PROPOSED TECHNICAL SPECIFICATION

Marked-up Technical Specification Table 4.4-5

REACTOR VESSEL MATERIAL SURVEILLANCE PROGRAM - WITHDRAWAL SCHEDULEUNIT 3.

This proposed amendment revises Technical Specification Table 4.4-5 to allow FPL to move surveillance capsule X from the 50' vessel location to the 270' vessel location. This capsule move is requested in order to place it in a higher flux position.

FIGURE 1. ARRANGEMENT OF SURVEILLANCE CAPSULES IN THE TURKEY POINT UNITS 3 and 4 PRESSURE VESSELS

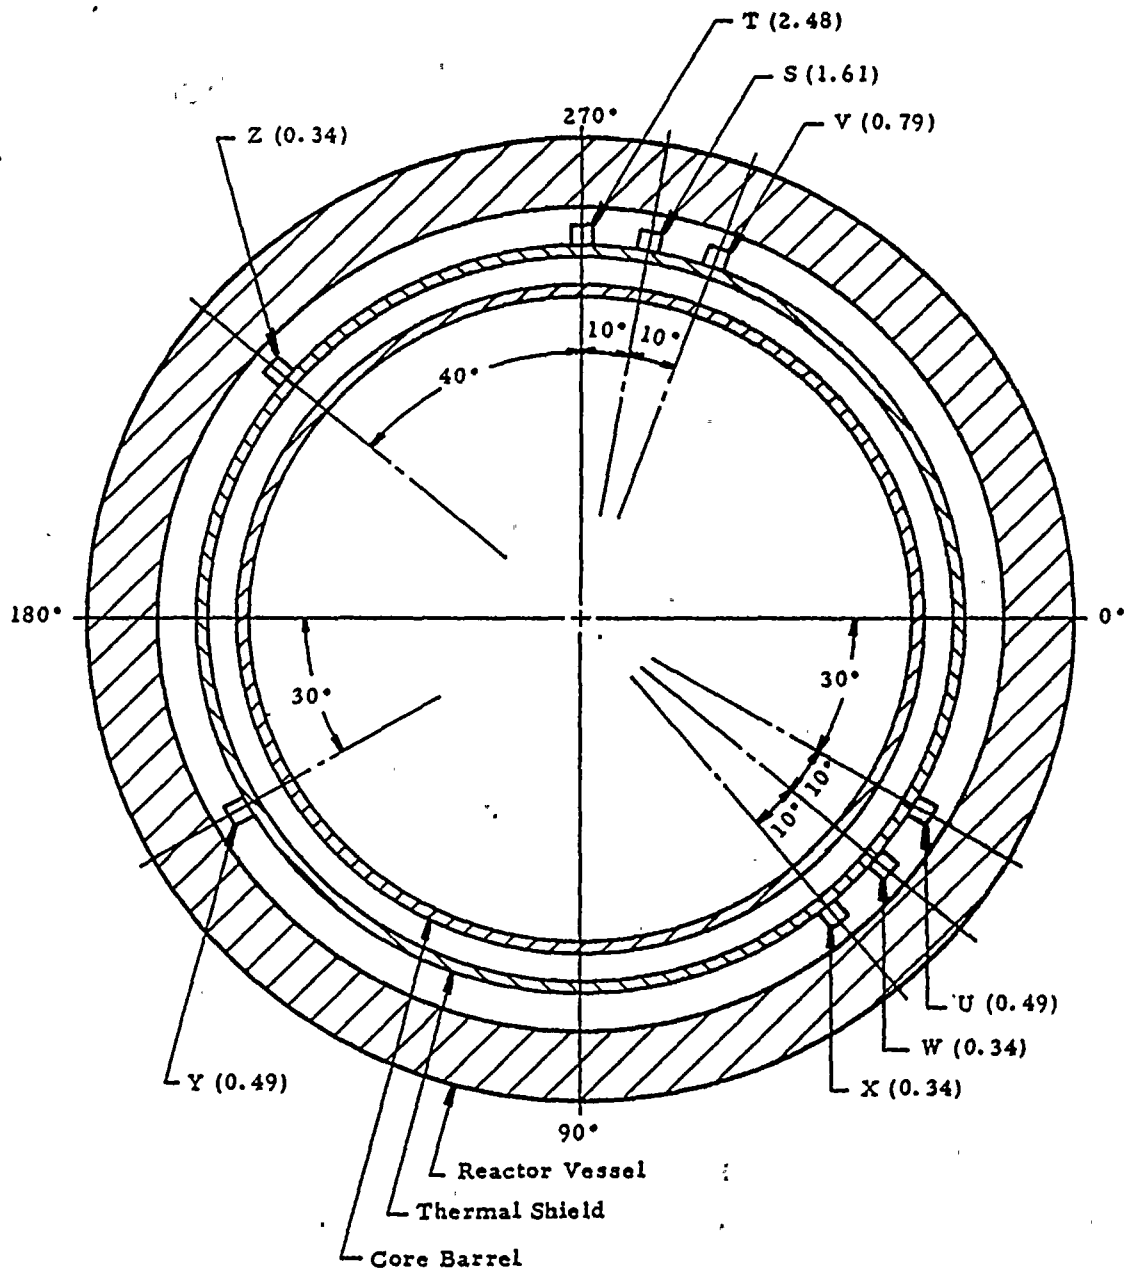
The X capsule currently has a "lead" factor of 0.34 based on its placement in the Unit 3 and 4 reactor vessels (see figure 1). The lead factor is determined by the ratio of the neutron fluence at the surveillance capsule to the neutron fluence at the reactor vessel inside surface. The 270' vessel position, formerly occupied by capsule T (removed from the Unit 3 and 4 reactor vessels in 1974 and 1975, respectively), has a lead factor of 2.48. By moving surveillance capsule X to the surveillance capsule T position, it would accumulate fluence at a much greater rate than the reactor vessel.

The placement of surveillance capsule X in a higher flux position would enhance our capabilities to predict the end of life reactor vessel properties, and conform to the recommendations of ASTM E 185-82 regarding accumulated neutron fluence for an end of life capsule. Capsule X is scheduled to be removed from the Unit 3 reactor vessel after 33 years of operation. The Unit 4 capsule X is a standby capsule.
